Implementation of New Propulsion System for the Replacement of the Tustumena Vessel Serving Rural Southwest Alaska

APPENDIX B: TECHNICAL VOLUME

TUSTUMENA REPLACEMENT VESSEL DESIGN REFRESH.

TUSTUMENA REPLACEMENT VESSEL DESIGN CHANGES.

SECTION 2-5A
BODY PLAN
1/8"=1'-0"

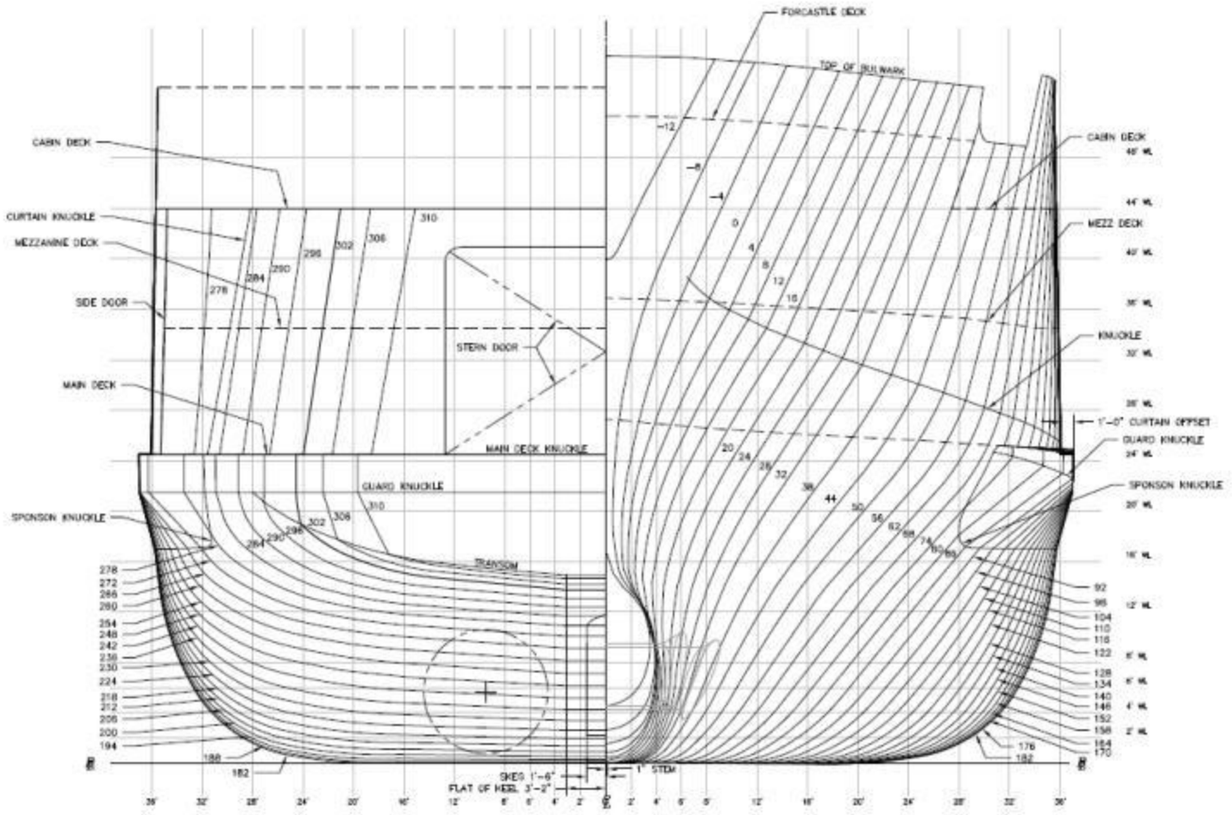
- Stability meets all new stability regulations. USCG/IMO/SOLAS.
- Beam increased by 3' for stability compliance.
- LOA did not increase, but LWL was increased to compensate for increased beam and hull lines changed accordingly.

New profile

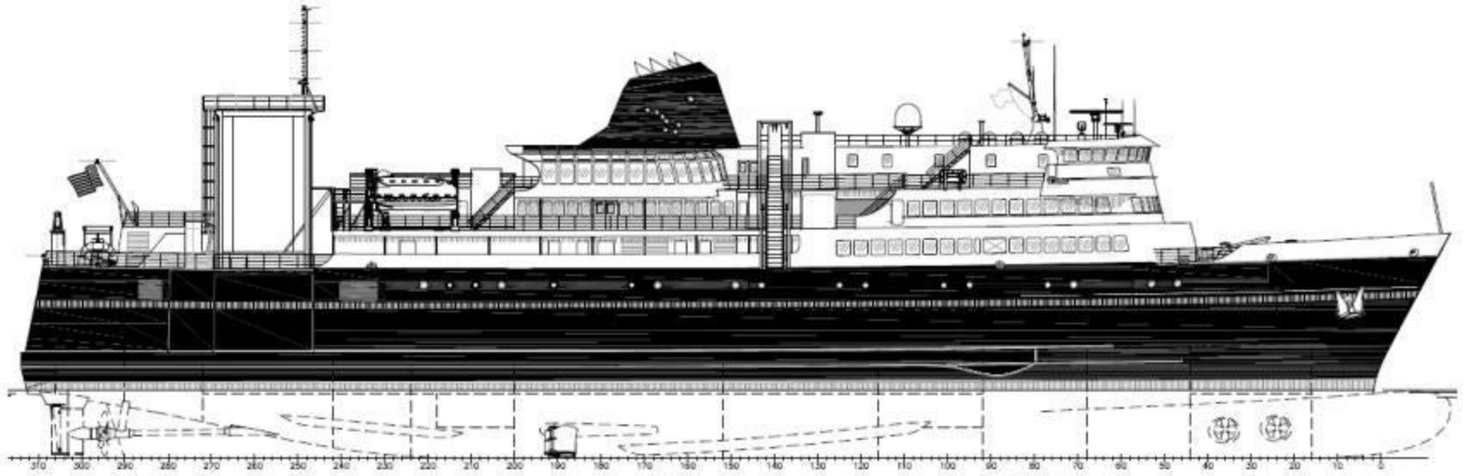
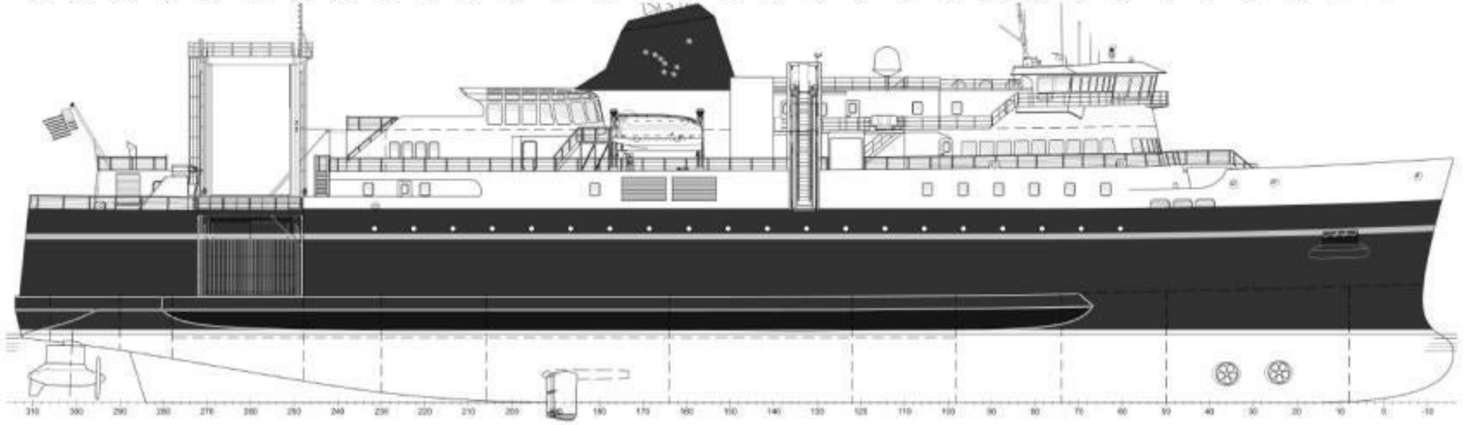
- Raised foc'sle to improve dryness of the foredeck and pilothouse.
- Modified Pilot House to improve visibility from control stations and better comply with regulations. Raised Pilot House 4 ft to allow electronics to be installed in space below.
- Waterline length increased to reduce powering requirements.

PLAN 6-4C
MAIN DECK

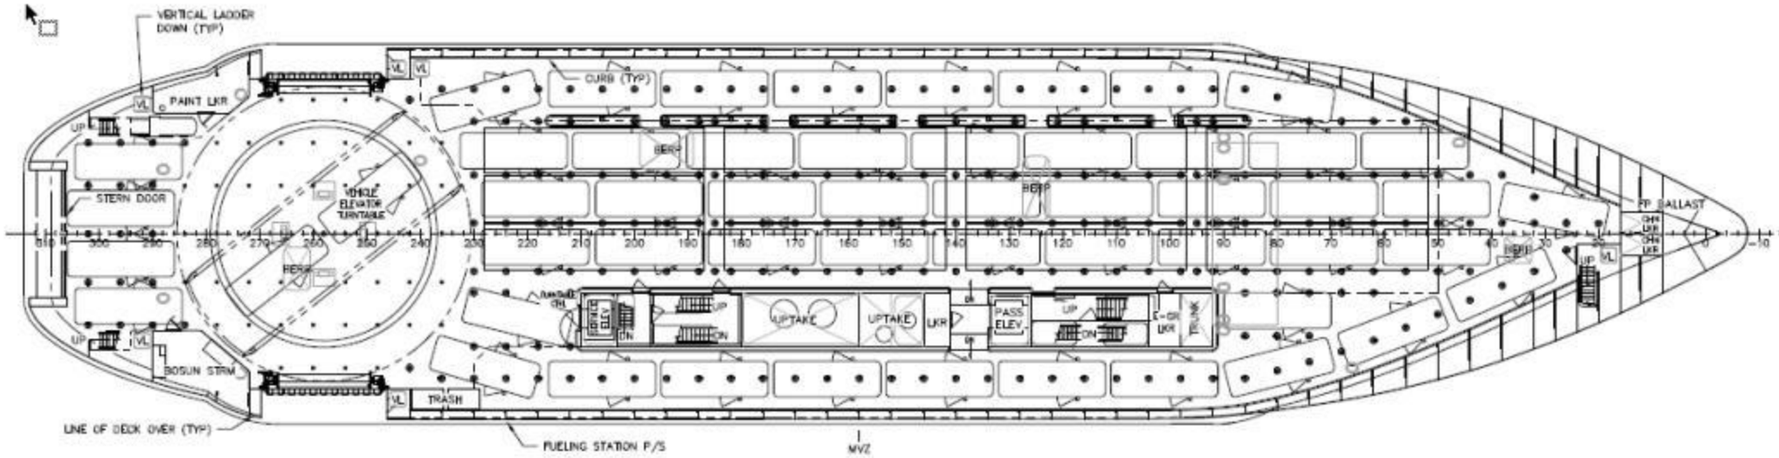
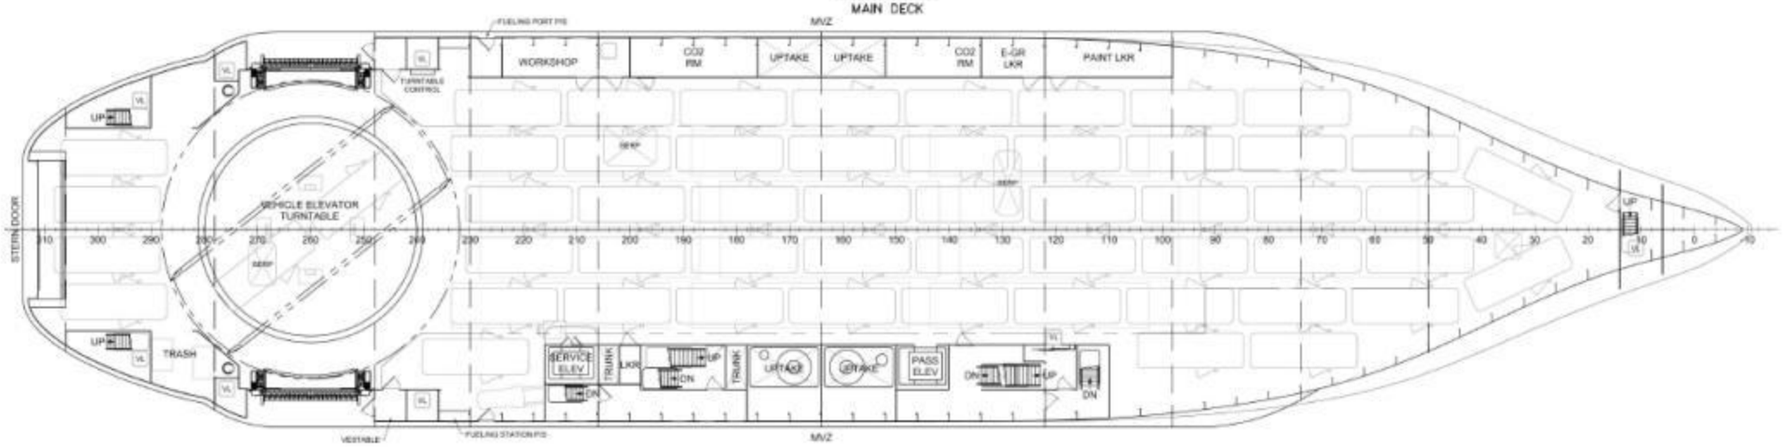
- Reconfigured Main Deck and vehicle space for the increased beam.
- Van capacity increased from 12 to 14.
- Vehicle capacity increased from 54 to 55.
- Changed casings to outboard of vehicle stowage area similar to ACFs.

PLAN 5-4A
MEZZANINE DECK

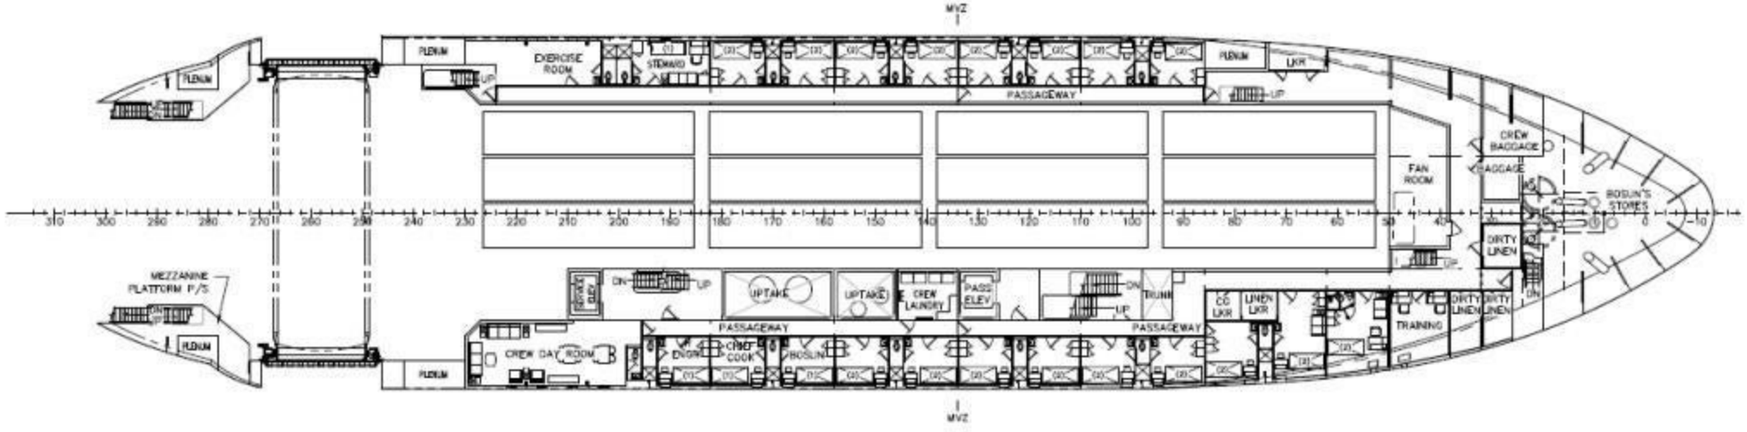
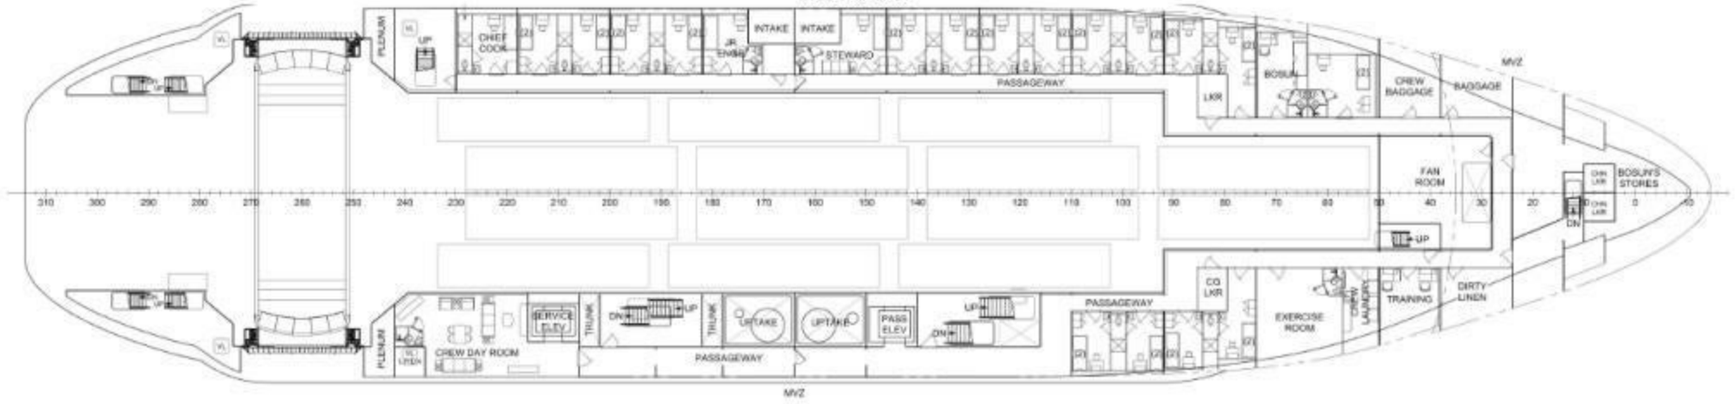
- Reconfigured Mezzanine Deck and vehicle space for the increased beam.
  - Van capacity increased from 12 to 14.
  - Changed casings to outboard of vehicle stowage area similar to ACFs.

PLAN 5-4C
CABIN DECK

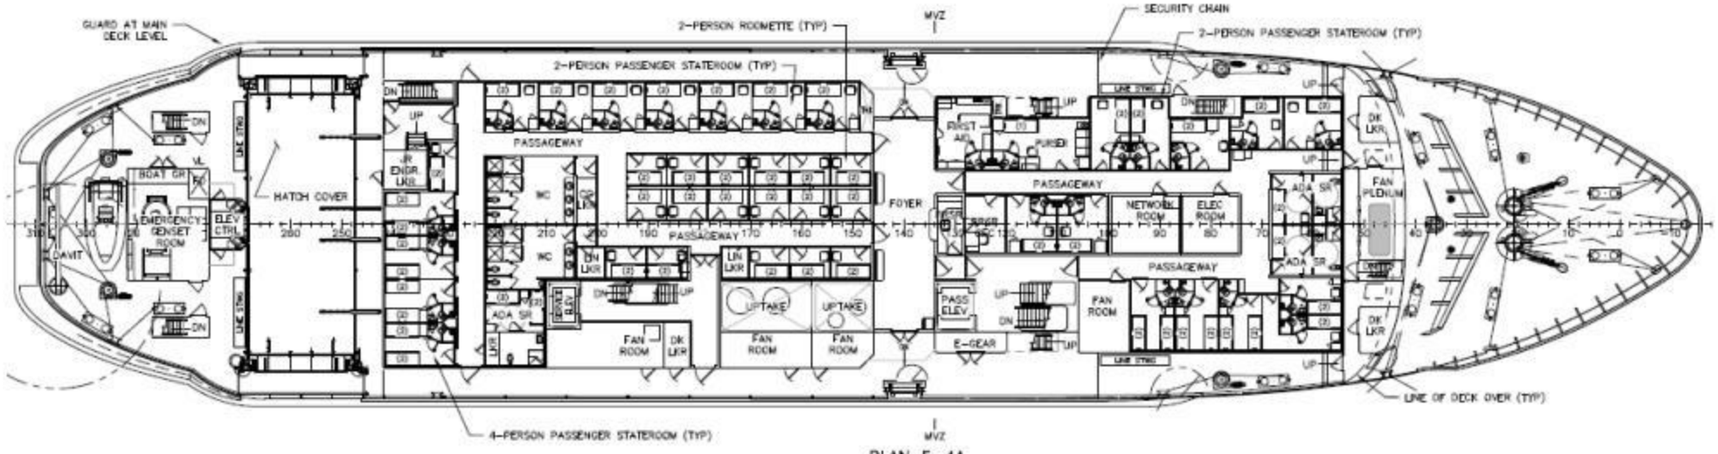
- Reconfigured Cabin Deck for the increased beam and outboard machinery casing changes.
- Overall number of passenger berths increased from 104 to 126 berths.

PLAN 4-4A
BOAT DECK

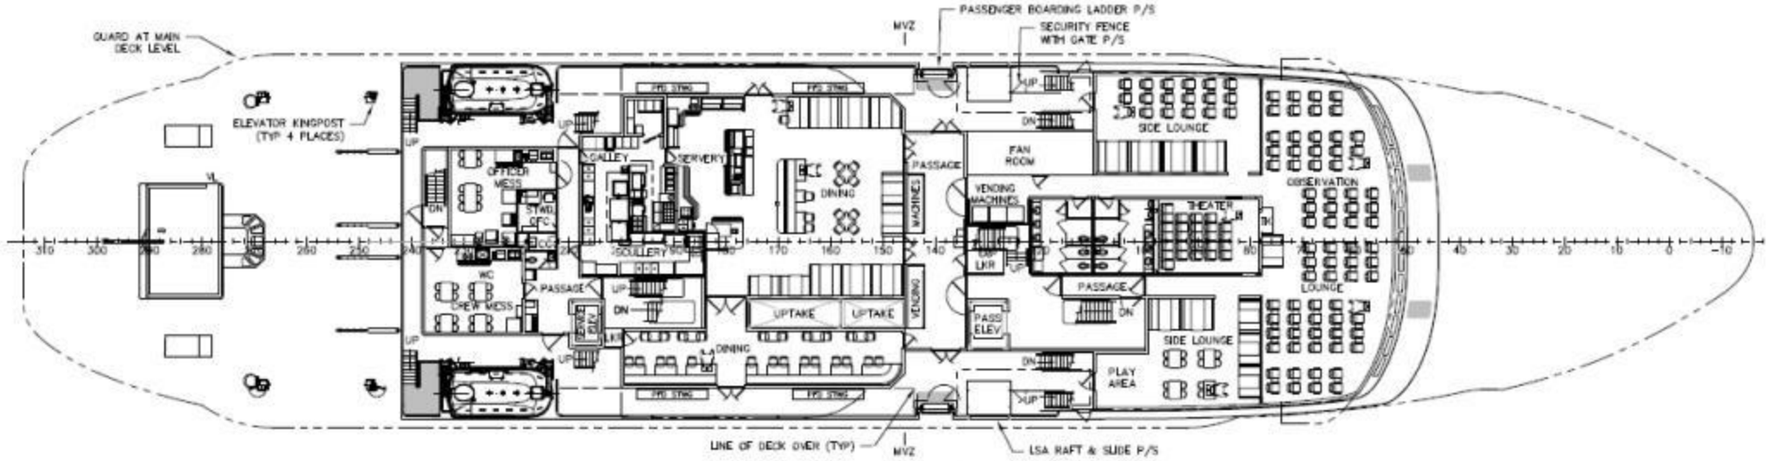
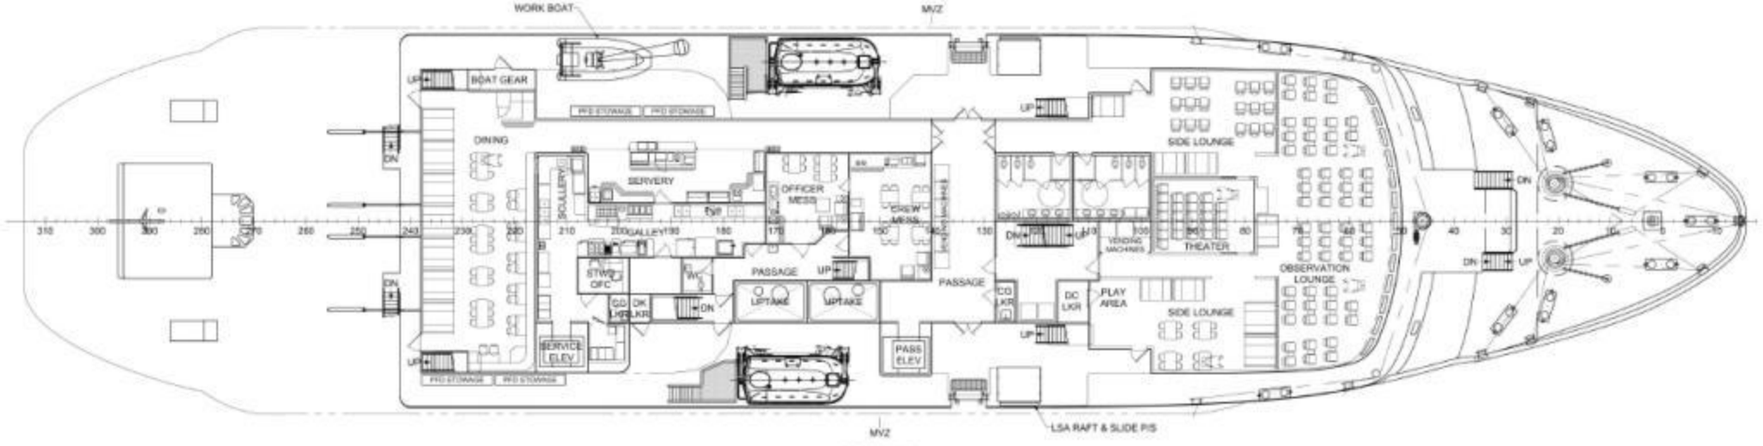
- Reconfigured Boat Deck for the increased beam and machinery casing changes.
  - Added outside walkway forward of observation lounge.
  - Moved passenger dining aft and crew dining forward of galley. Similar to other AMHS Ferries.
  - Relocated work boat forward. May be replaced by rescue boat if desired.

NEW 1ST PLATFORM PLAN.

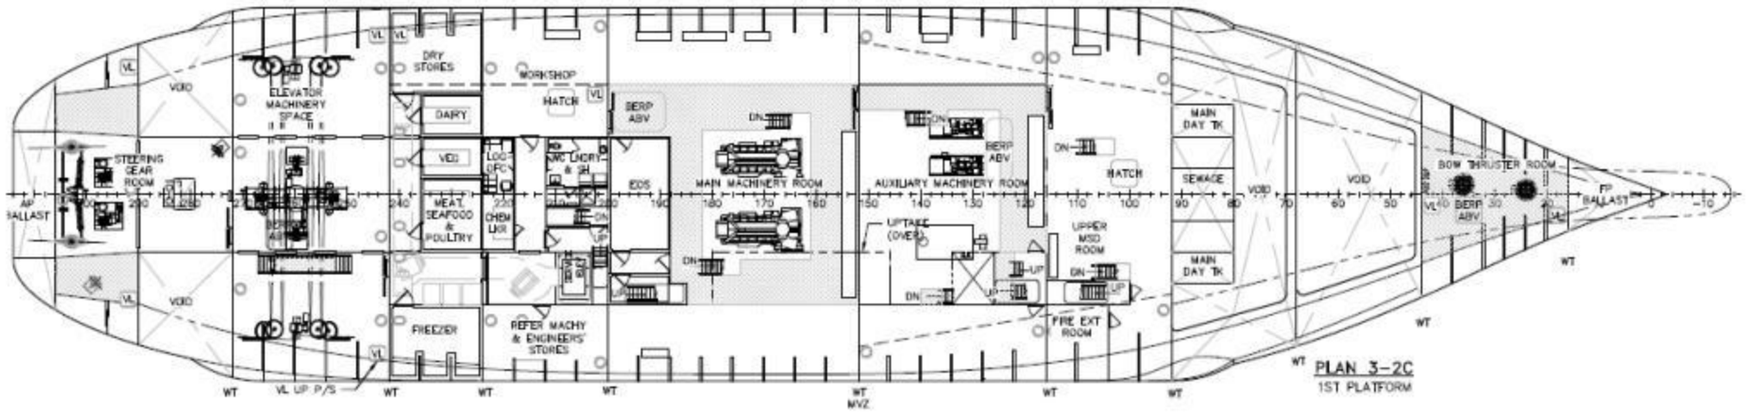
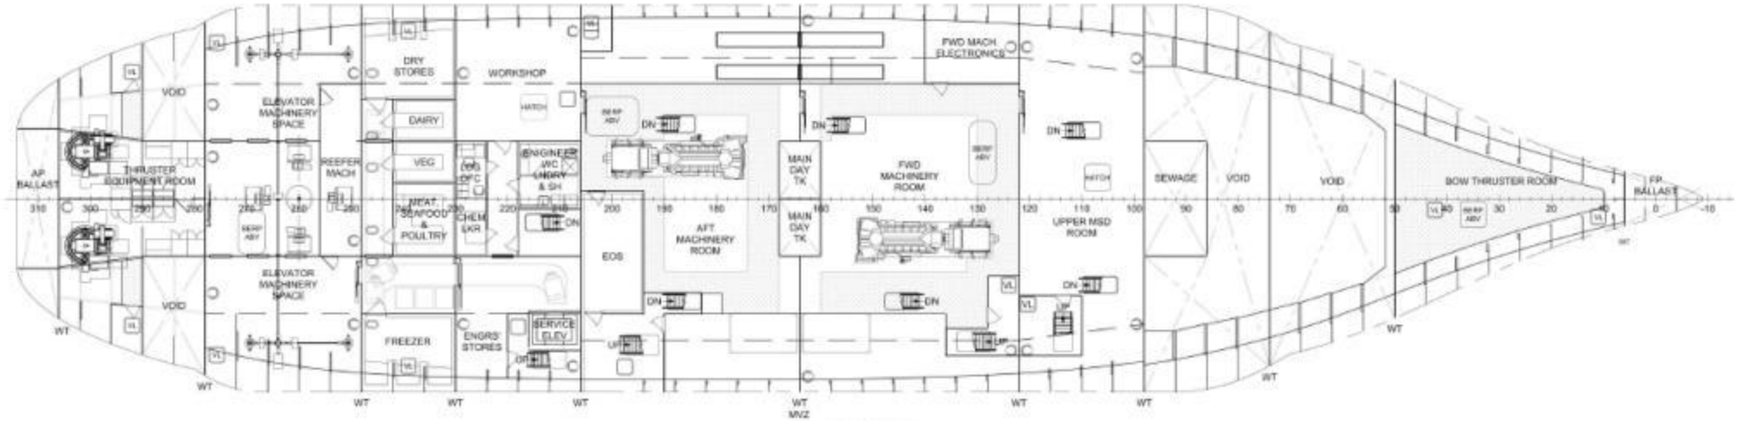
- Changed VETS to ball screw design to comply with ASME elevator code.
- "SOLAS Ready" impacts:
  - Redundant engine rooms for compliance with Safe Return to Port (SRtP).
  - Changed to podded propulsion for SRtP compliance.
  - Changed to diesel electric propulsion to comply with Energy Efficiency Design Index (EEDi) and support the podded propulsion.
